Part 2b of a Review
of
ASSESSMENT OF EPA's RESIDENTIAL WOOD HEATER CERTIFICATION PROGRAM
Test Report Review: Stoves & Central Heaters
Written by NESCAUM, March 2021
and
ALT-140
and
Valid vs. Invalid Test Sequences

Reviewed by:
Thomas Morrissey
Woodstock Soapstone Company, Inc.
66 Airpark Road
West Lebanon, NH 03784
July 2, 2021

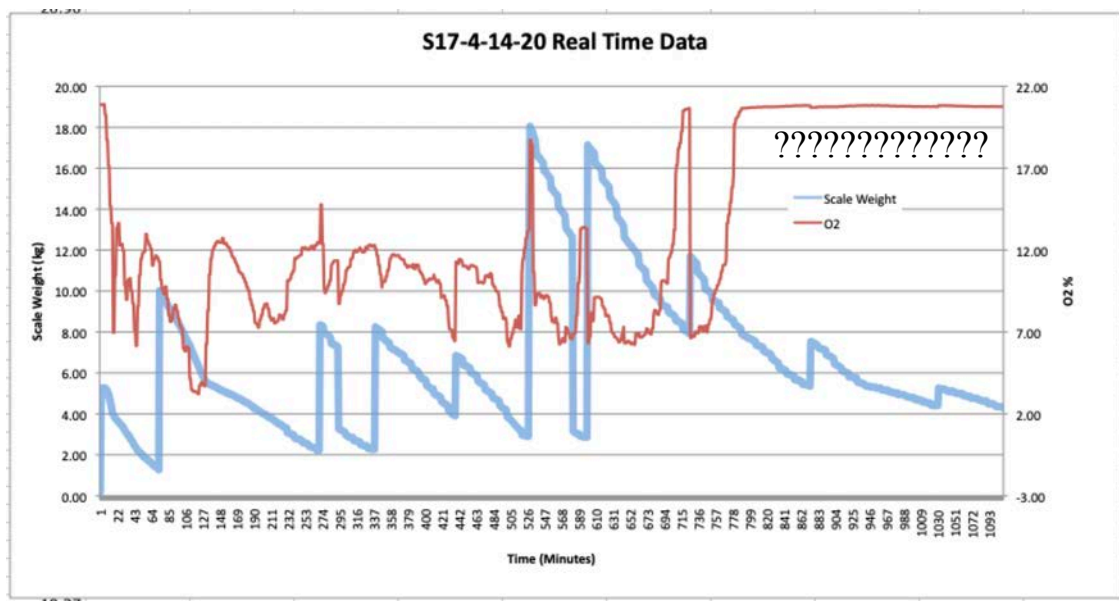
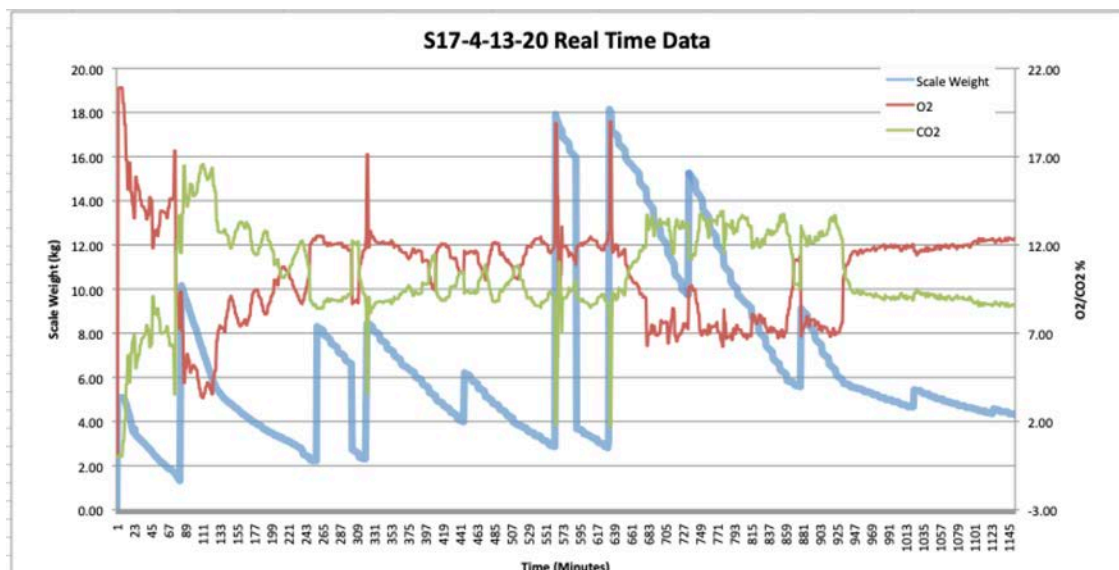
In order to get approval for ALT-140, ADEC also sent EPA some results for "Stove 17." When I first charted the reported results for "Stove 17" the results were

truly bizarre. Here are the initial plots for tests S17-4-13-20 and S17-4-14-20, which appeared to include multiple loading events and did not conform to the protocol.

Through an exchange of emails with EPA (in the interest of transparency, reproduced as an appendix to this Review), we were able to ascertain that the spreadsheet data ADEC submitted to EPA was disorganized, and rows of results were out of sequence. We are still missing an explanation for the anomalous recordings of

oxygen (as well as CO and CO₂) over the last 5.5 hours of the 4/14/20 test. Normally these test failures would render a run invalid, but we have no back-up data to determine what actually happened.

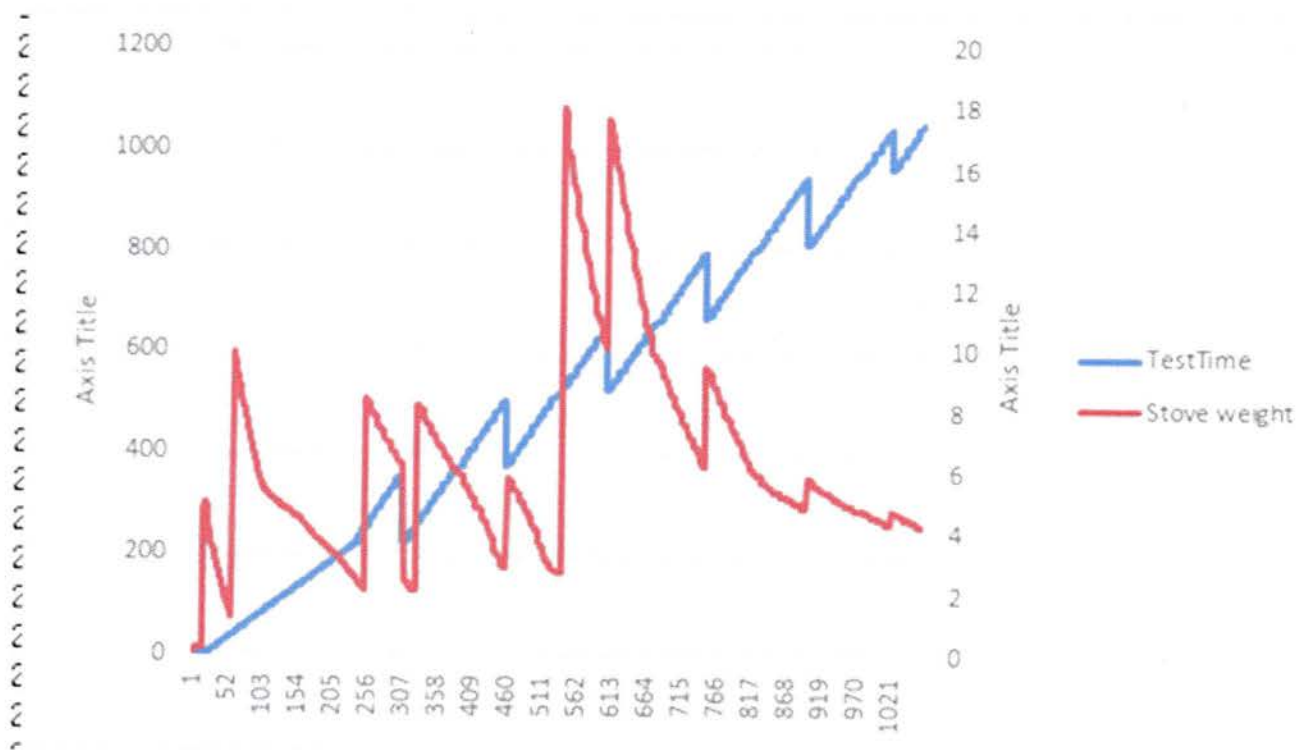
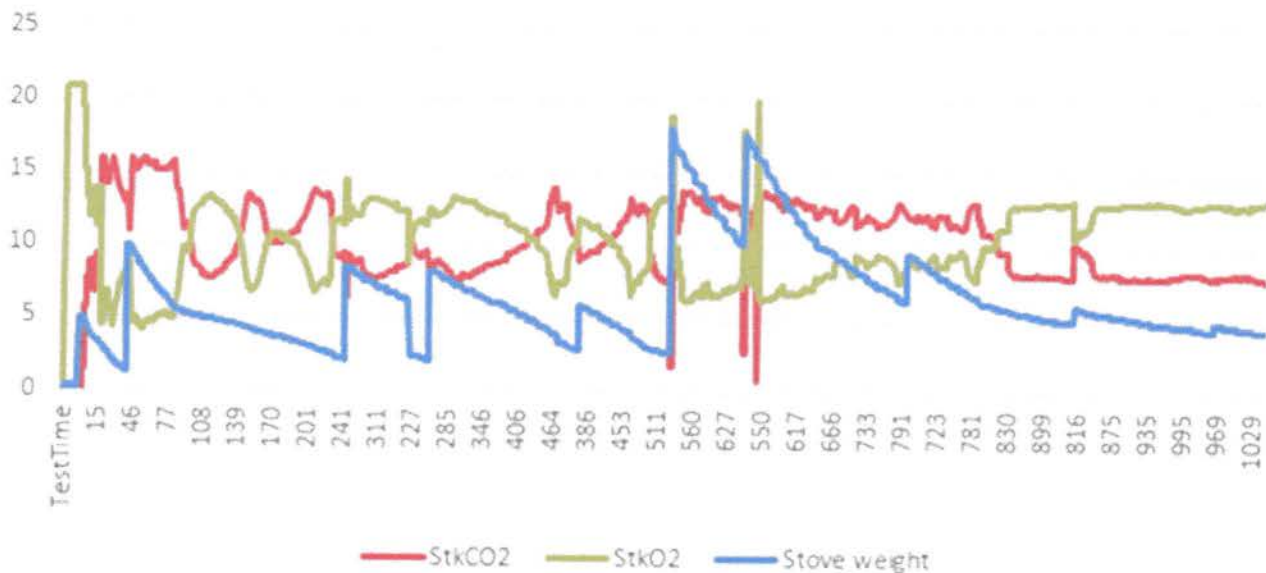
As you can see in the graphs below, behind the issues you pointed out regarding the stove weight and O2/CO2 swings are missing data points from the data acquisition system. It seems that on a regular basis ten minutes of data are simply absent (the time-line should be a straight line, not jagged).

See the second chart. Looks like DAQ jumps in the data. Time varies but it is usually ~10 min of data missing from the spreadsheet. This is consistent for stove 17 test days. They seem to have fixed the problem by the time they did a 4th test on 4/29/20 on stove 7.

We'll be following up on this with Alaska and asking for a complete test report. ATM-140 will remain in suspended status until we receive that and review the data.

S17-4-15-20 Real Time Data

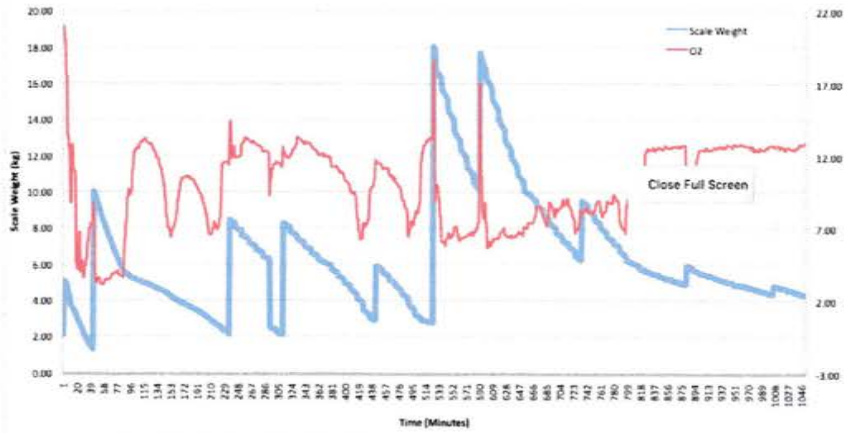
On Stove 17, if you sort up under "test time" (Column B), then the data falls back into place, and the loading assumes a normal curve. I'm not sure how it got so muddled.

We still have a middle run with no O2 measurements for 5.5 hours.

The stated CO measurements also seem extremely high *to me*, relative to stated emissions. It would be helpful to see those calcs. It's a lot of work to weed through this data jumble.
